SUBJECT: Murray Hill Arts Center ADA Renovations
Contractor: J. L. Ruby Construction, LLC
Contract No: 10057

Forwarded herewith for execution is Change Order No. 1 for subject project.

CITY OF JACKSONVILLE
 DEPARTMENT OF PUBLIC WORKS
 ENGINEERING DIVISION
 CONSTRUCTION CHANGE ORDER

Change Order No. One (1) Date October 5, 2015
 Description of Project Murray Hill Arts Center ADA Renovations
 Name of Contractor J. L. Ruby Construction, LLC
 Contractor's Address 2236 Jones Road, Jacksonville, Florida 32220
 Contract No. 10057
 Account No. See attached Original Contract \$185,000.00
 + Previous Change Order No. 0 \$0.00 + Change Order No. 1 \$39,753.25
TOTAL REVISED CONTRACT \$224,753.25

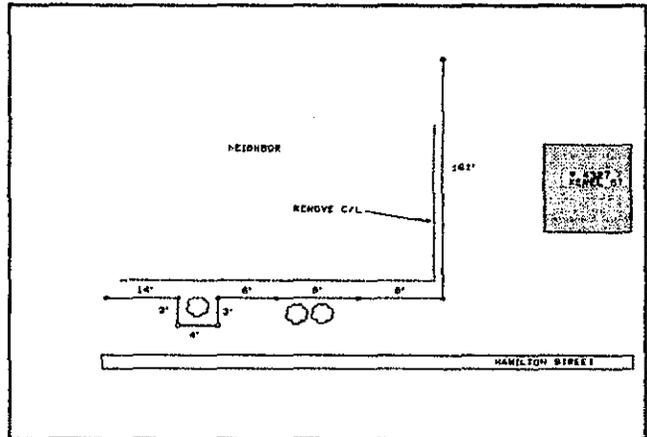
207' OF 6' HIGH VINYL FENCE
STYLE-TONGUE AND GROOVE (TOTAL PRIVACY)
COLOR-WHITE

SECTIONS ARE 6' ON CENTER - WILL USE TWO
SECTIONS 8' ON CENTER AT TREE WE GO BEHIND
AND BOX THE OTHER TREES THAT ARE ON THE
LINE
